Interactive comment on “Water droplet calibration of a cloud droplet probe and in-flight performance in liquid, ice and mixed-phase clouds during ARCPAC” by S. Lance et al.

S. Lance et al.

Received and published: 23 October 2010

Fig. 1. (S1) Optical Schematic of the CDP

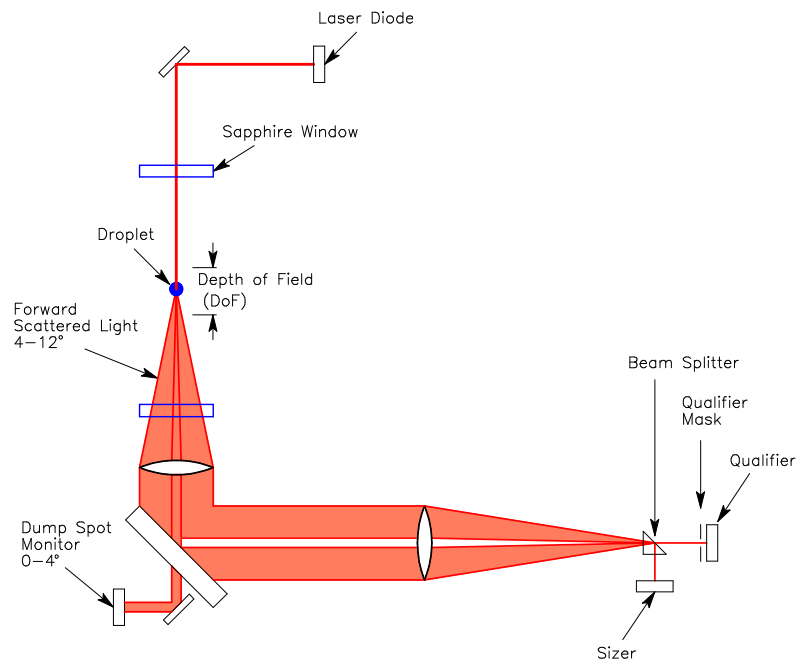
"The comments below don't necessarily reflect this, but I think the importance that the qualifier and sizer signals take on later in the paper require a lot more careful explanation of how this works in the instrument. A figure illustrating this would go a long way to helping the reader out."

"3141, 5-6: I'm still a bit unclear how this works. This sentence makes it sound like the total light scattered is then divided between the qualifier and sizer, whereas later I infer that at least the intensity as a function of scattering angle information must be preserved. I think a picture would help this out immensely. I also think it's such an important part of what happens later that you should take the time to explain this well."

"3155, 8-9: "scatters additional light into the sizer" why isn't this additional light seen

The basic operation of the two detectors (qualifier and sizer) are essentially the same as in the CAS and the FSSP, which have been written about in detail in many papers (e.g. Baumgardner et al, 2001; Burnet and Brenguier, 2002; Hovenac and Lock, 1993). However, since the optical geometry is central to our discussion of coincidence errors, and since it seems that there was confusion about certain aspects of this, we now add a figure to illustrate the basic optical configuration of the CDP (Figure S1).

You are correct that the scattered light is collected and split between the qualifier and sizer. It is unclear why you would infer that the intensity as a function of scattering angle is preserved, since that is not written here or elsewhere, so we cannot respond about this. To assist the reader, we now add a figure to illustrate the basic optical configuration of the CDP (Figure S1).

Because the qualifier has an optical mask (see Figure S1).

Fig. 2. (S2) Simulation of evaporating water droplets

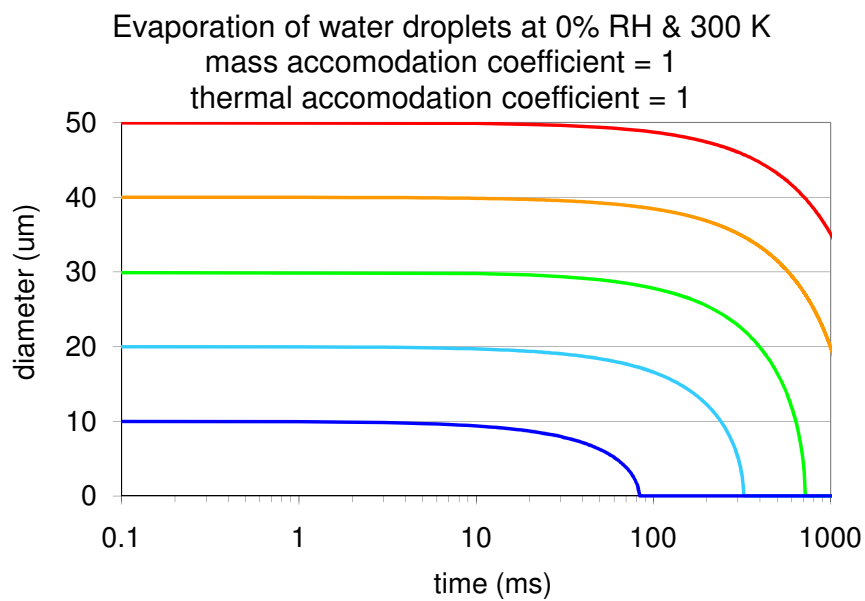
"3145, 26: might this velocity change cause a temperature of the air? if so, any chance the drop size responds to this?"

Yes, the temperature of the air increases as a result of airflow acceleration. However, the drop size is not expected to respond significantly to this increase in temperature given the short duration that the droplets are exposed to these changing conditions prior to detection (< 1 ms, given a generous 10 cm boundary layer upstream of the laser beam and an aircraft velocity of 100 m/s). Even if ram pressure heating could bring the temperature to 300K and the relative humidity to 0% (unrealistically hot and dry conditions), 10 μm droplets would shrink due to evaporation by less than 1% if exposed to those conditions for 1 ms (See Figure S2).

Fig. 3. (S3) Calibrated sizer and qualifier signals as a function of position within SAQ for 22 μm (top) and 12 μm (bottom) droplets

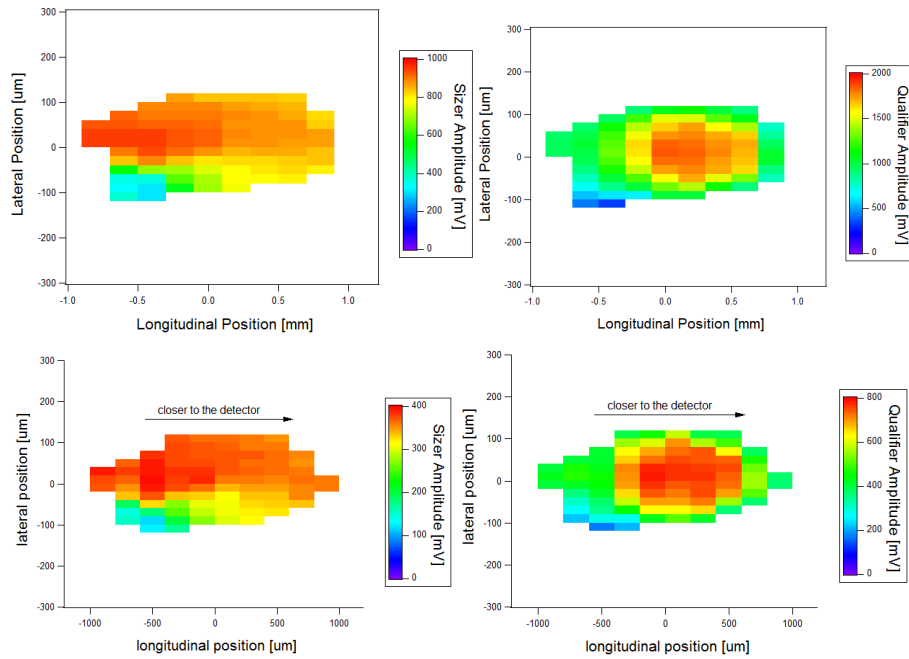
"What I'm confused by is why the calibration was done like this in the first place. Since the drops pass through lower intensity parts of the beam, isn't it necessary to calibrate based on all trajectories that will be accepted by the CDP, and not just the ones with max amplitude? Why should this 2 um shift be needed? Couldn't one just traverse the cal drops through the beam until they're rejected by the instrument and then weight each stream by its likelihood?"

The red symbols represent single droplets that have been transmitted across SAQ at the center of the DoF. We mistakenly wrote in the paper (Page 3149, Line 25) that these points represent the maximum sizer pulse amplitude, when, rather, the qualifier pulse amplitude is maximum at this location (See Figure S3). We made this mistake again, by incorrectly stating (Page 3150, Line 4) that "...the calibration using water droplets is constrained to the center of the DoF where the scattered light signal is highest..." In actuality, the scattered light signal (recorded by the sizer) is greatest at the edge of the DoF, not at the center of the DoF (again see Figure S3).

Yes, the instrument response at different locations within the sample area needs to be accounted for. The calibration method suggested by this reviewer has been implemented, with the results reported in Figure 4 of the paper (and Figure S3). We assume that all streams within SAQ are equally likely. At this point we would obtain additional calibration points for other droplet sizes (averaging the response over all positions within SAQ, as we did for 12 and 22um droplets), however the instrument has been optically modified since the date of publication. Because the average response for 12 and 22 um droplets was consistent with the response for various droplet sizes at the center of the DoF, as calibrated on two separate days (Figure S4), we believe that the reported results are sufficient for our analysis.

Fig. 4. (S4) Updated version of Figure 2 from the paper (see full caption in the text)

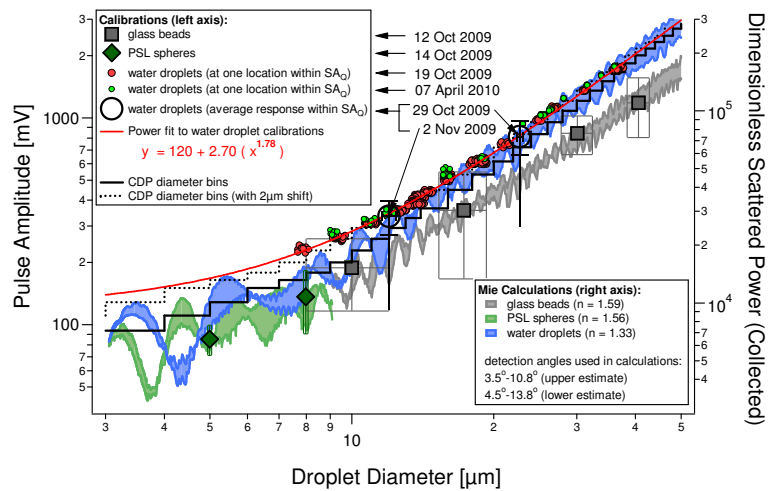
"Leads to Fig 2 issues as well - it's not clear what is supposed to agree with what (like the red symbols, the way the cal was done, shouldn't actually correspond to the blue "curve", for example). left and right axes reversed in caption? also, if units are Watts, add to axis label. I like the uncertainties for the calibration points, but they're hard to see - I'd suggest making them darker (esp. for the PSL)."

"Again, the issue of why one expects Fig 3 standard measurement data to line up along the 1:1 curve is odd - you selected only a small subset of possible trajectories and thus there's no reason to think that the CDP standard measurement is valid here. It only works as an average if you send drops along all trajectories, right?"

We now include in Figure 2 of the paper the sizer signal averaged over all positions within SAQ (Figure S4), obtained from the calibrations reported in Figure S3 (for 12 and 22 μm droplets, respectively). The average response agrees well with the response reported for droplets at the center of the DoF. Again, this contradicts the statements above that we are now retracting from the paper.

Yes, the caption has the left and right axes reversed – that has been fixed. We also darken the error bars for the PSL and glass bead calibrations.

Figure S4 Caption: Figure 2 from the paper with additional water droplet calibrations added. The average sizer pulse amplitudes (as well as the standard deviation, minimum and maximum) are shown for calibrations with 12 μm and 22 μm water droplets, respectively, over all positions within SAQ. Also shown are water droplet calibrations of various sizes near the center of the DoF on another day (about 6 months after the calibration that was originally reported in the paper). These added data illustrate that calibrations at the center of the DoF are representative of the average instrument response.

We do have reason to suspect that these observations (with droplets of various sizes transiting across the center of the DoF) are a valid representation of the average CDP response. We have now added the average CDP response for 12 and 22 μm over all positions within SAQ to Figure 2 of the paper (See Figure S4).

Fig. 5. (S5) Simulated CDP response function assuming various degrees of misalignment (see full caption in the text)

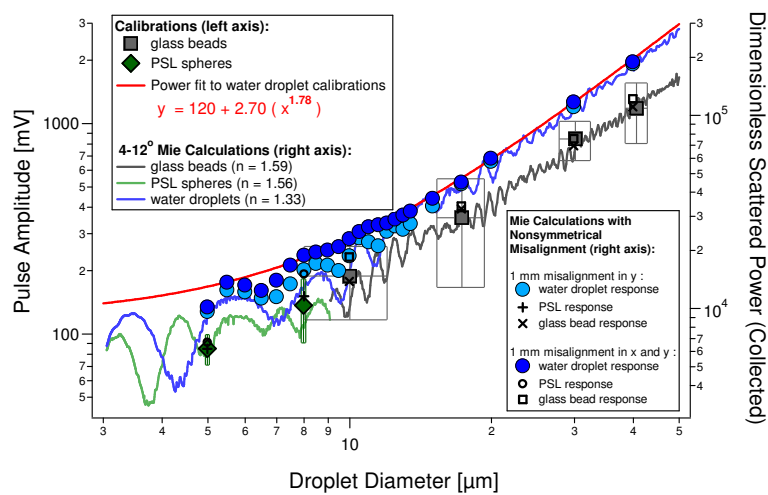
"30: I'm also very surprised by this - and I think it deserves more discussion than this. Other people have been able to reproduce this behavior in other optical instruments, and I'm assuming it's been done for the FSSP though I don't know for sure. But in any case, it must say something important about either the optical model used for the instrument or the calibration method or the instrument itself. Is there some way to address this further?"

This is a very good point – and we have spent a good deal of time attempting to address it. We calibrated another CDP in the lab and were able to reproduce Mie resonance structure. Therefore we do not believe that there is a problem with the calibration method. We have also duplicated the monotonic response with the CDP reported in this paper (Figure S4).

We speculate that the optical model is insufficient for this particular instrument due to optical misalignment (beyond the symmetrical ± 0.5 degree shift modeled). If the qualified sample area is out of alignment with the center of the laser beam, this would result

Figure S5 Caption: The calibrated response of the CDP to PSL and glass beads, and the calculated response for PSL, glass beads and water droplets assuming that all forward scattered light 4-12 degrees is collected by the sizing detector. The light blue dots show the modeled CDP response for water droplets given a 1 mm misalignment in the y-dimension (laterally across the laser, and perpendicular to the droplet trajectories). The dark blue dots similarly show the modeled CDP response for water droplets given a slightly greater misalignment. The fit to the water droplet calibrations is shown for comparison. The CDP response to PSL and glass beads, given these misalignments, are also shown, and often agree well with the PSL and glass bead calibrations.

Fig. 7. (S7) Interarrival times randomly distribution between 0 and 2τ (blue) versus a Poisson distribution (red). See full caption in text.

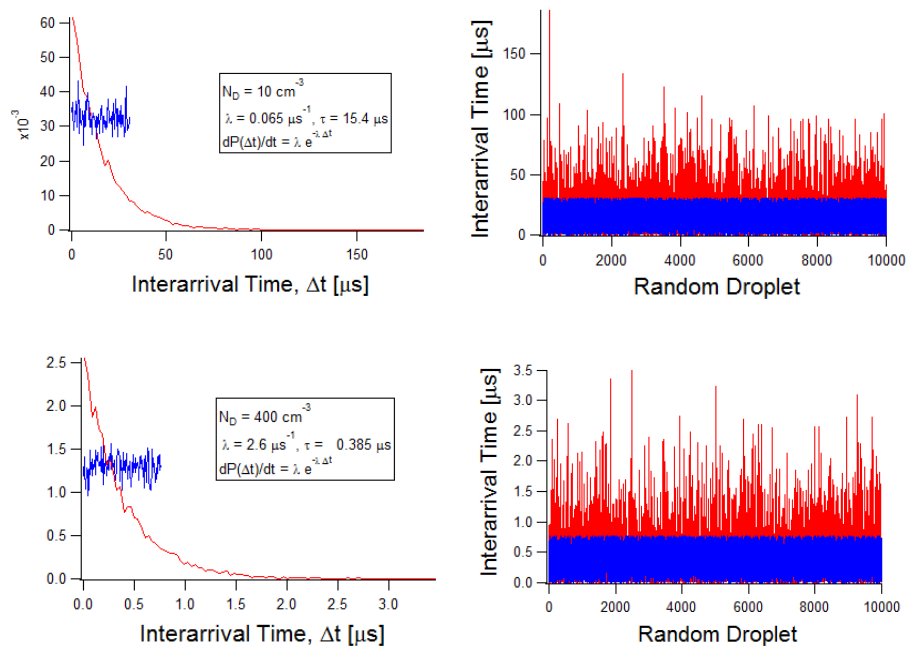
"3153, 20: Can you explain the implications for choosing an inter-arrival distribution that's uniform and limited to $2 * \tau$? In the absence of any small-scale clustering, one would expect the distribution to be Poisson with mean (and standard dev) of τ , which means there's a long tail to larger τ values than you use here. Would using a more realistic distribution change the results?"

Great question! We reran the simulations (with the same input size distribution and pulse widths), but instead of using a random distribution of interarrival times between 0 and $2 * \tau$, we used a Poisson distribution of interarrival times [Field et al, 2003].

Figure S7 shows a comparison between these interarrival time distributions. Although the probability distributions are clearly different, there was no significant change in the coincidence errors when using the Poisson distribution (Figure S8). We now briefly describe these additional simulations in the paper here.

Figure S7 Caption: Interarrival times randomly distributed between 0 and 2τ (blue) and a Poisson distribution of interarrival times (red) for droplet concentrations of 10 cm^{-3} (top) and 400 cm^{-3} (bottom), respectively. Figures on the right show random sampling from each of these distributions and figures on the left show the probability distributions.
